Re: FortisBC Energy Inc. (FEI)
2026 Long Term Gas Resource Plan (LTGRP)
Response to the British Columbia Utilities Commission (BCUC) Information
Request (IR) No. 1

FortisBC Energy Inc. (FEI or the Company) 2026 Long Term Gas Resource Plan (LTGRP)	Submission Date: July 20, 2026
Response to BCUC Information Request (IR) No. 1	Page 2

Figure 1: Annual Demand – Residential and Commercial Sectors

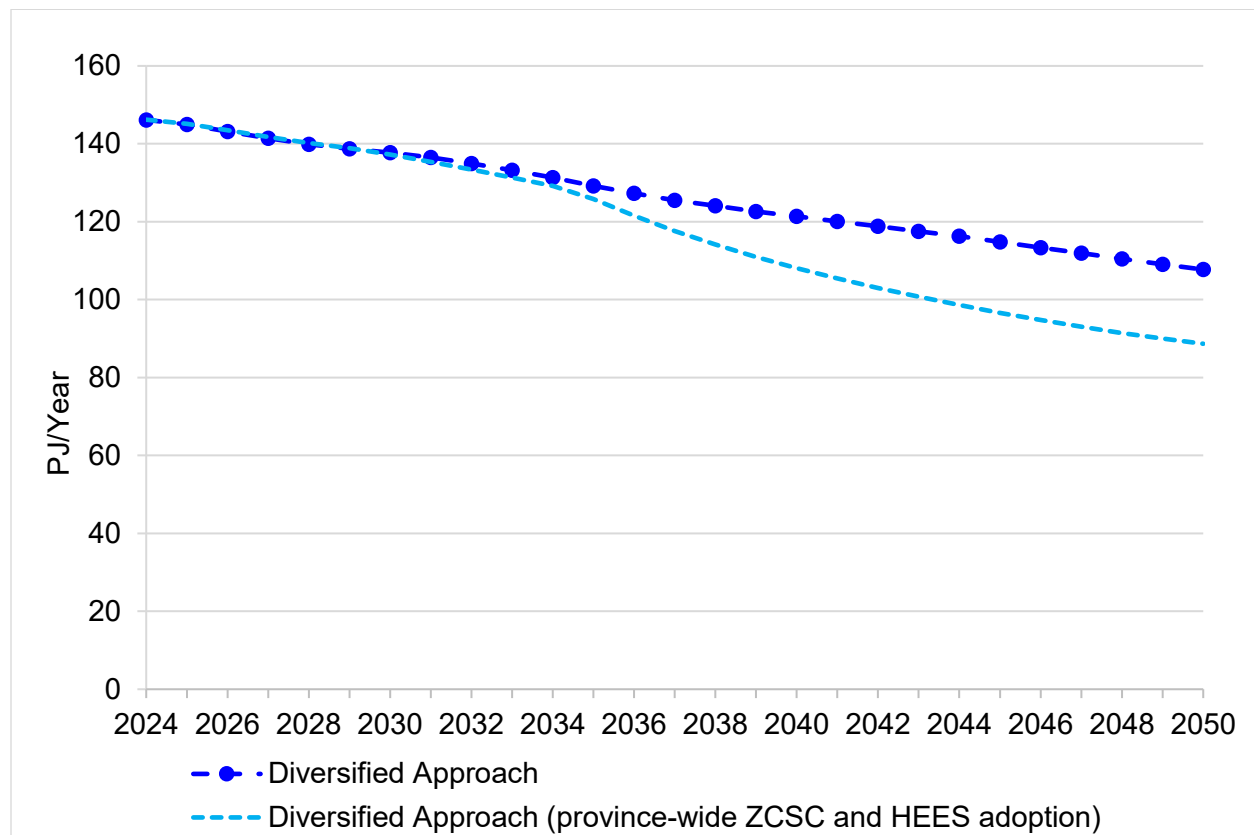
1.2.1 Please describe a high level or directional impact on FEI's annual and peak demand forecast if a province-wide ZCSC adoption by 2030 were included in the Diversified Approach scenario.

Please refer to Figure 1 below which shows the effect on annual residential and commercial demand based on a version of the Diversified Approach scenario that includes province-wide ZCSC and HEES adoption by 2030.

At a high level, FEI expects that, if the ZCSC and HEES were adopted and implemented province-wide by 2030, residential and commercial peak demand would be reduced relative to the System Peak Forecast by 2044, while industrial demand would be unaffected. FEI estimated the high-level peak demand impacts of fuel switching from the HEES by applying the proportional change in annual energy consumption to peak demand. As a high-level approximation, this estimate (using an energy-to-peak demand proxy) does not account for hourly load shapes or the coincidence of space and water heating loads during the system peak hour. Consequently, the estimated peak demand reductions are indicative and should not be interpreted as a detailed assessment of peak-hour impacts.

Figure 7-18: System Peak Forecast Method for the ITS with DSM

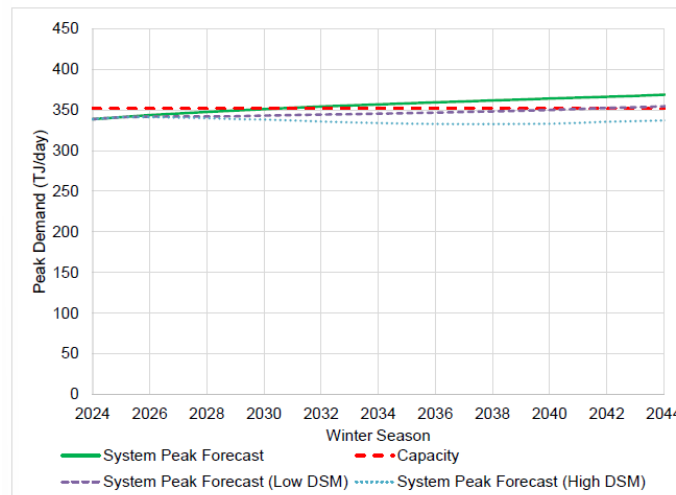
9.1 Please clarify if FEI's forecast of the peak hour use per customer (UPC_{peak}) values take FEI's advanced DSM programs into account, and discuss any current DSM offerings that assist with lowering peak demand on FEI's system.

Any of FEI's current DSM programs that reduce energy during a peak day will contribute to a lower peak demand, and most current DSM programs contribute to system peak reductions. This includes HVAC equipment, including gas heat pumps, building envelope improvements, and industrial equipment, amongst others. In addition, FEI is currently piloting gas demand response to assess if that would further assist with reducing peak demand.

Revised Figure 4-18: Lifecycle Costs and Benefits from Participant Cost Test Perspective

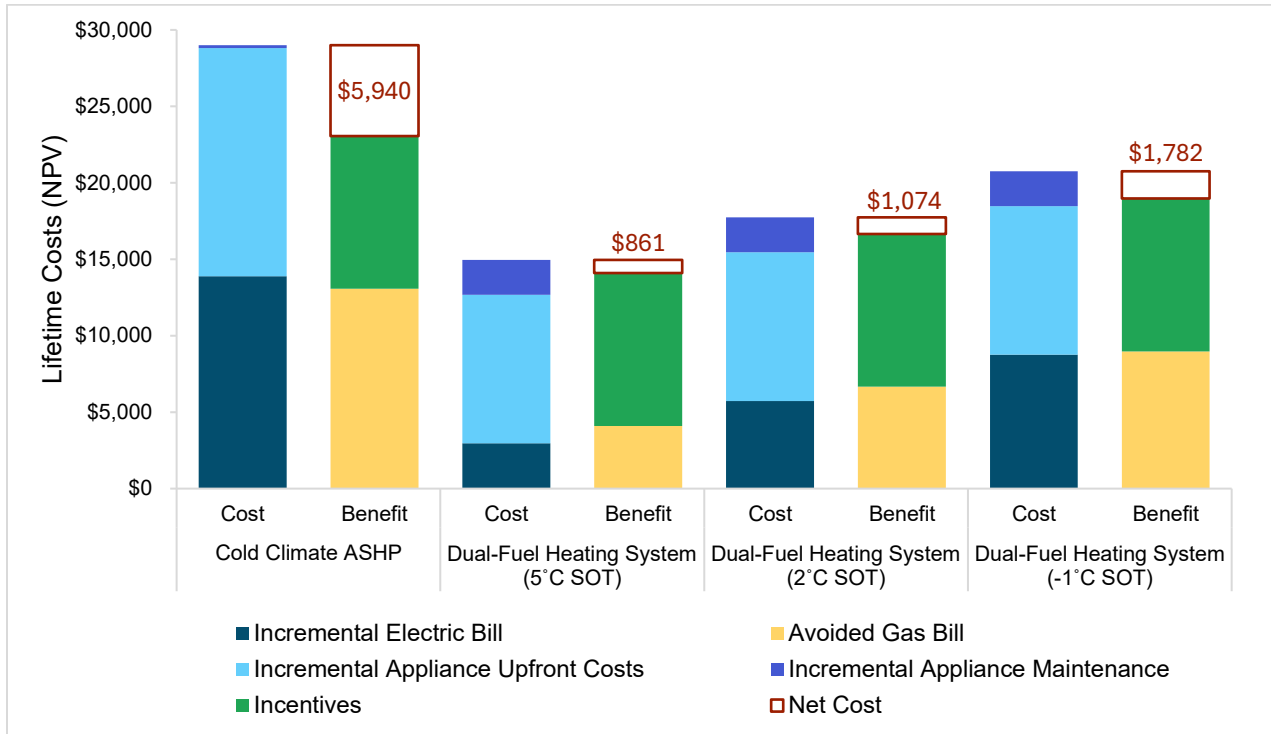
11.7 If available, please provide an updated version of Figure 4-18 showing the lifecycle costs and benefits for a dual-fuel heating system with a switchover temperature of 5°C, and -1°C. If such analysis is not available, please estimate the proportional and directional impact.

Please see the revised version of Figure 4-18 below which includes dual-fuel heating systems under the alternative SOTs of 5°C and -1°C.

Revised Figure 4-23: Total Avoided Building Emissions at Lower Switchover Temperatures

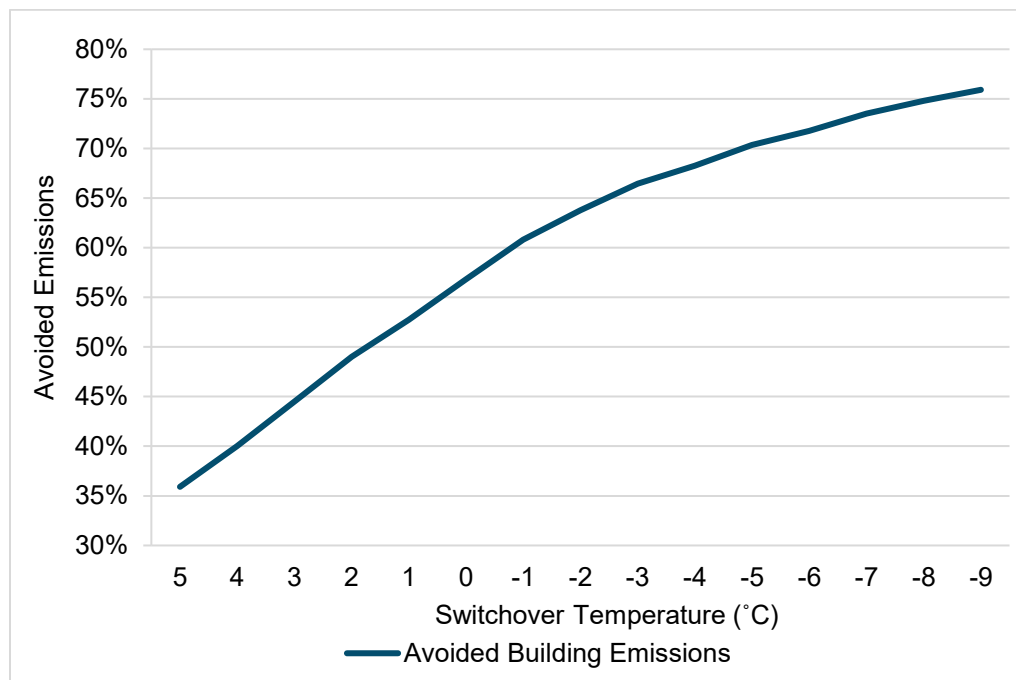
12.1 Please provide an updated version of Figure 4-23 showing the avoided building emissions for an extended range of 5°C to -9°C, including any necessary explanations to account for differences in regional performance.

A revised version of Figure 4-23 has been provided below to show total avoided building GHG emissions over an expanded range of SOTs from 5°C to -9°C.

Figure 4-21: Household Abatement Values (PCT Perspective) from Heating Options¹²⁶ and RNG Blend Percentages

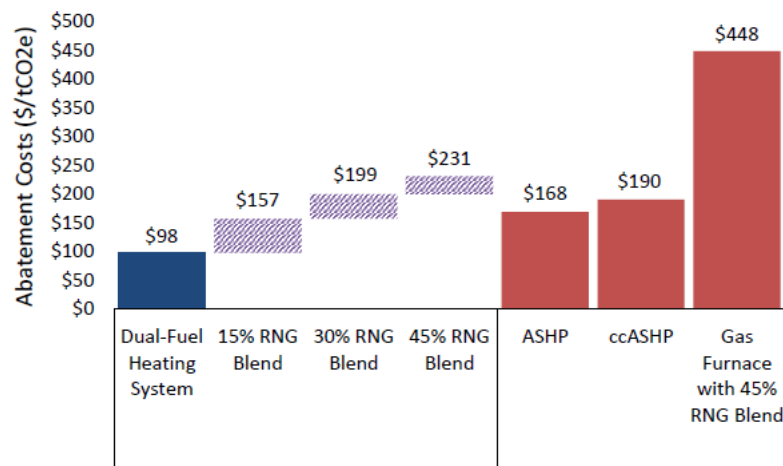
12.3 Please provide the total GHG emissions for a dual-fuel heating system using a 45 percent RNG blend, compared to the ASHP options shown in Figure 4-21.
